Memorandum

TO: Analysis Group, Burns & McDonnell

FROM: David Patton, Pallas LeeVanSchaick

RE: MMU Comments on Independent Consultant Initial Draft ICAP Demand Curve Reset Report and the forthcoming draft of NYISO Staff DCR Recommendations

Figure 1: B-Rated Bond Yield, August 2019 to July 2020

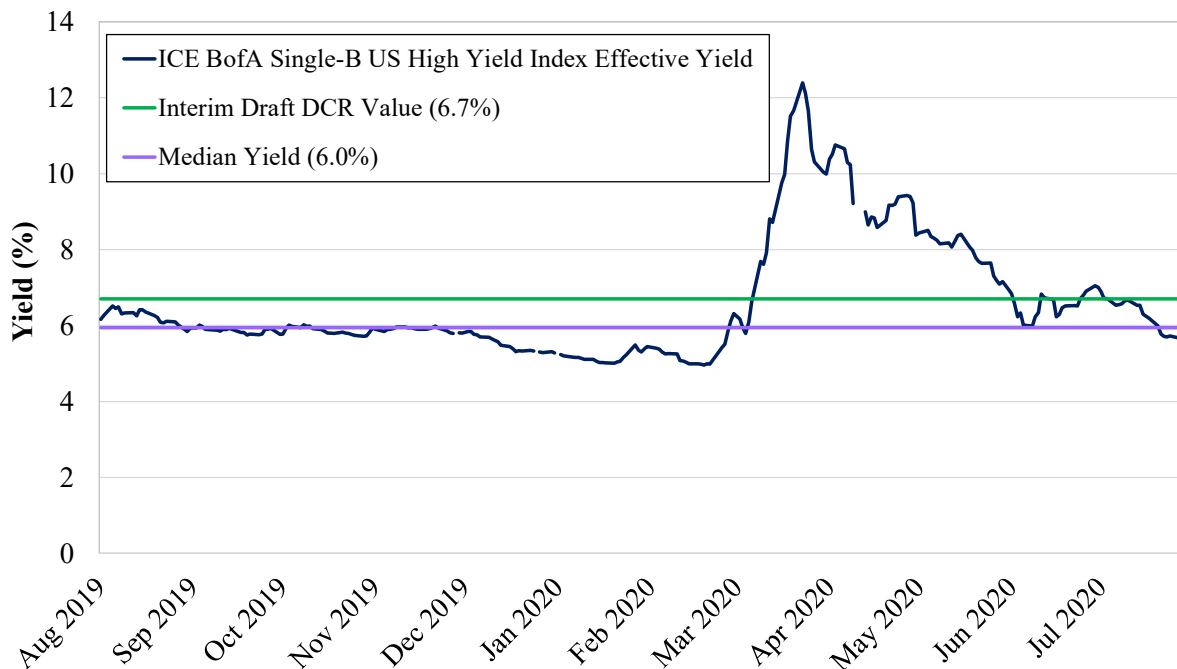
Market conditions have changed considerably since the consultants developed their initial recommendation. Figure 1 shows the Single-B US High Yield Index Effective Yield from the Federal Reserve Bank of St. Louis for the year from August 2019 through July 29, 2020.

Figure 1 shows that yields began to rise sharply in late February and remained elevated in April and May. These substantial increases reflected severe liquidity issues in the credit markets that have not been sustained. When presenting their rationale for a higher cost of debt in May 2020,

the consultants pointed to the sharp increase in debt costs that occurred between March and April. In particular, the consultants highlighted costs of B-rated debt at 12.4 percent on March 23 and 9.3 percent in the week of April 21.² Since May, Figure 1 shows that the B-rated corporate debt benchmark has fallen considerably.³ Yields then fell close to pre-COVID-19 levels in June and have fallen below 6 percent in July.

The purpose of this analysis is not to suggest that only the most recent yields during July 2020 should be used. Rather, it is to highlight that recent trends should provide grounds for extreme caution in considering how debt yields during the first half of this year will relate to the cost of borrowing for the entirety of the 2021-2025 demand curve reset period. A principled approach to establishing all demand curve parameters is to seek values that reflect a reasonable expectation of the parameter over the reset period. Such an approach to calculating the cost of debt (e.g., a rule-based method such as using the median over a significant period of time) will avoid giving undue weight to short-term market fluctuations.

While the 6.7 percent cost of debt recommended by the consultants in their Interim Final Draft Report is more reasonable than the 7.7 percent draft recommendation, it is still significantly above what a historical review of benchmark rates would support. Median yields over the historical periods shown in Table 2 are consistent with our recommendation to assume a cost of debt between 6.0 and 6.5 percent. It is appropriate for the historical costs used to establish this assumption to include data since the onset of COVID-19, but not to assign it disproportionate weight to this period. In fact, given that current yields are below 6.0 percent, it would be most reasonable to assume a cost of debt at the low end of this recommended range.

Figure 2: Cost of Reserves in DCR Model vs. Historical Average DA Reserve Offers

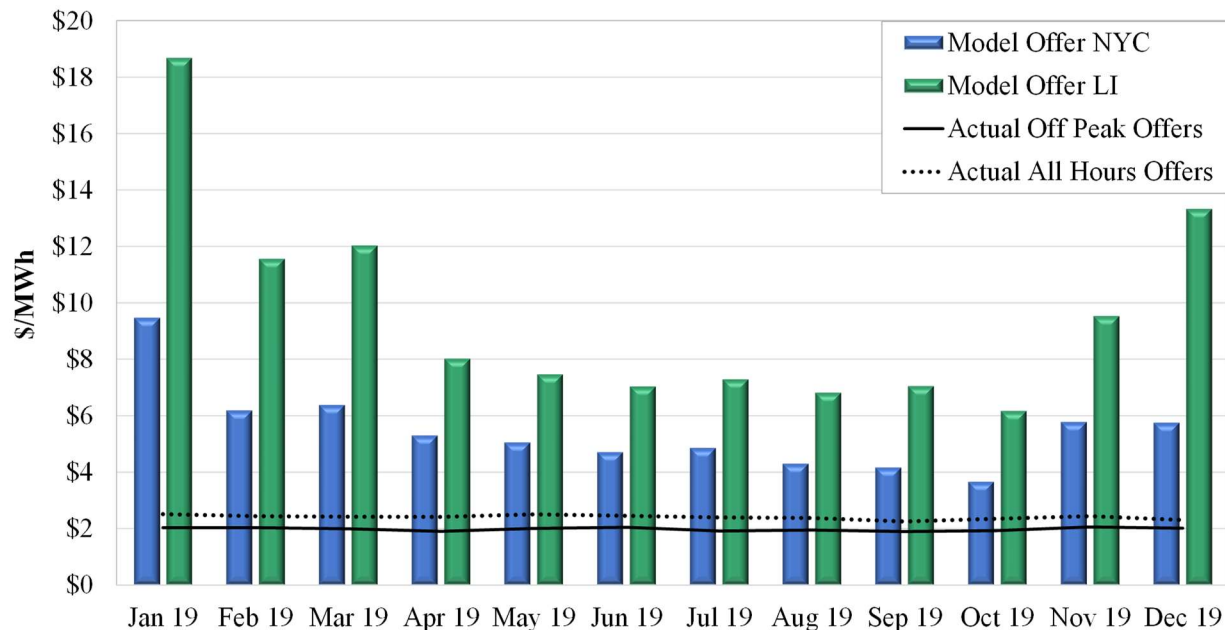
Actual reserve offer data from suppliers in New York is instructive given that these offers should reflect the costs the consultants are attempting to quantify. This data supports a cost of reserves of approximately \$2.0/MWh as shown in the following figure. Figure 2 compares actual historical day-ahead reserve offers for gas-only and dual fuel units in Load Zones J and K in 2019 to the implied cost of reserves in the current net E&AS model.⁸

Figure 2 shows that the capacity-weighted average reserve offer was \$2.0/MWh during off-peak hours, when offers are likely to be more competitive, and \$2.4/MWh in all hours. Typical reserve offers had little variation across months. By contrast, the current model methodology implies an average cost of \$6/MWh in Load Zone J and \$9/MWh in Load Zone K in 2019, with monthly averages as high as \$9 in Load Zone J and \$18/MWh in Load Zone K.

Based on this data, we recommend that the consultants replace the fuel-based cost of selling reserves in the day-ahead market with a constant cost of \$2.0/MWh. This will align the modeled cost with typical offer prices for similar existing units in New York. Failing to make this adjustment will lead to unrealistically low reserve schedules and net revenues, especially in Load Zones J and K. Table 5 shows the effects of implementing this recommendation.⁹

Figure 3: Map of Algonquin Pipeline

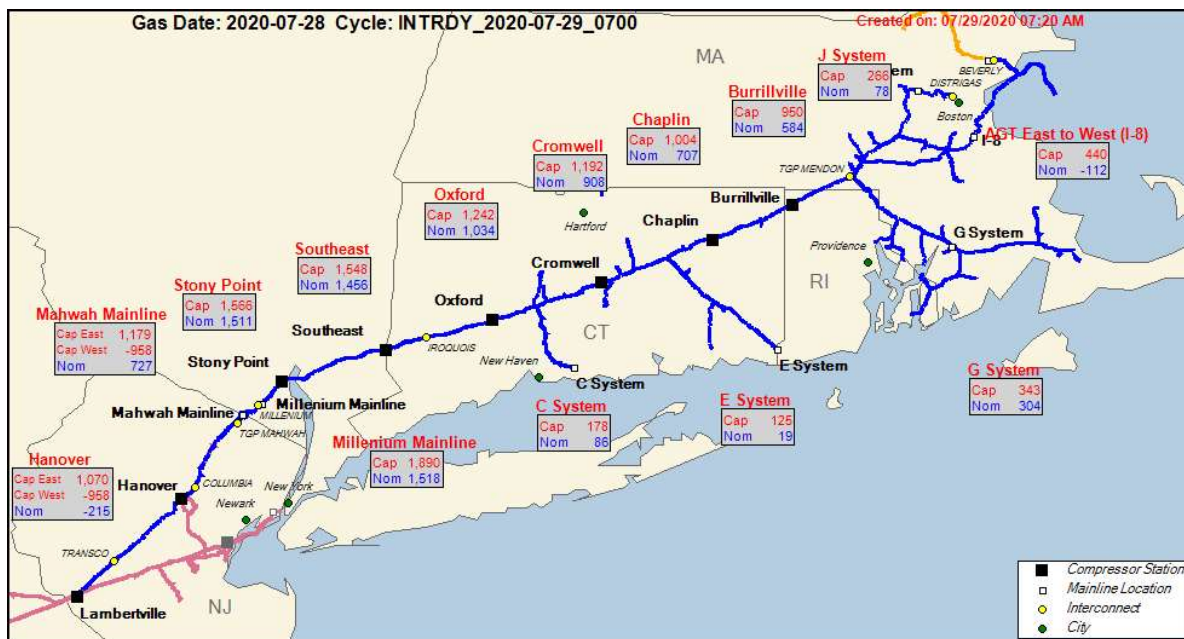
Pipeline data supports the finding that gas transported from the TETCO M3 zone via Algonquin is available in Rockland County. Algonquin announces any restrictions on customers’ gas transport nominations via daily critical notices when conditions warrant such restrictions. In 2019, Algonquin announced restrictions on interruptible nominations sourced from points west of its Stony Point Compressor Station for delivery east of Stony Point on 363 days, but did not announce restrictions on west-to-east transport for delivery west of Stony Point on any days. Stony Point is located on the west shore of the Hudson River at the eastern border of Rockland County (see Figure 3 below). Hence, while transport on Algonquin is frequently restricted, the main bottlenecks are located downstream. Transport to points in Rockland County such as the interconnect with Millennium Pipeline at Ramapo is generally available.

Figure 4: Operational Available Capacity on Algonquin Millennium Mainline Segment

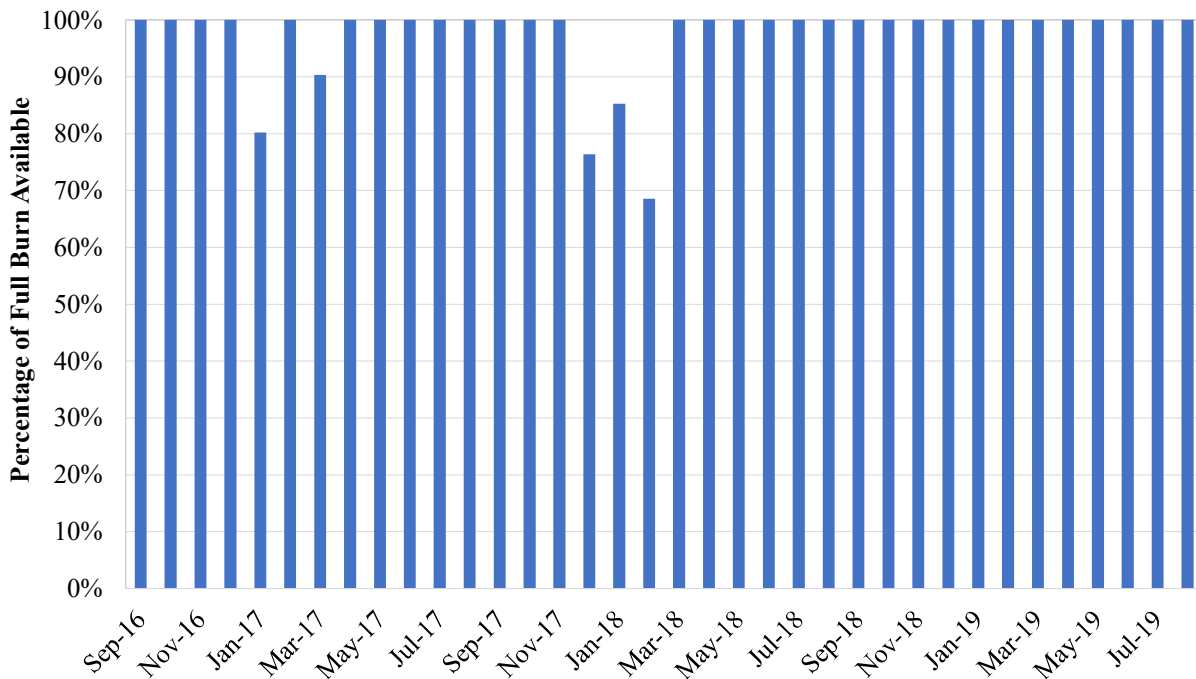
Figure 4 shows the average daily operational available capacity on the Algonquin pipeline segment passing through the Millennium Mainline station in Ramapo, NY as a percentage of the daily gas that would be required for the peaking plant to operate for 24 hours (approximately 75,000 Dth).¹⁵ Average available capacity exceeded the maximum daily burn in most months,

and covered a high percentage of maximum daily burn even in cold winter months. This is likely a conservative measure, as a peaking unit typically will not generate for all hours of a day. Furthermore, as noted above, the recommended peaking plant design for Rockland County is dual fuel and, therefore, also has the option to run on oil in the minority of days when gas may not be available.

Hence, we consider the consultants’ use of TETCO M3 plus \$0.27/MMBtu (along with the assumed intraday premium or discount of 10 percent) to be appropriate for the Rockland County unit, while use of the Algonquin Citygate or Iroquois Zone 2 hubs would be inappropriate given the county’s proximity to the TETCO M3 market zone.
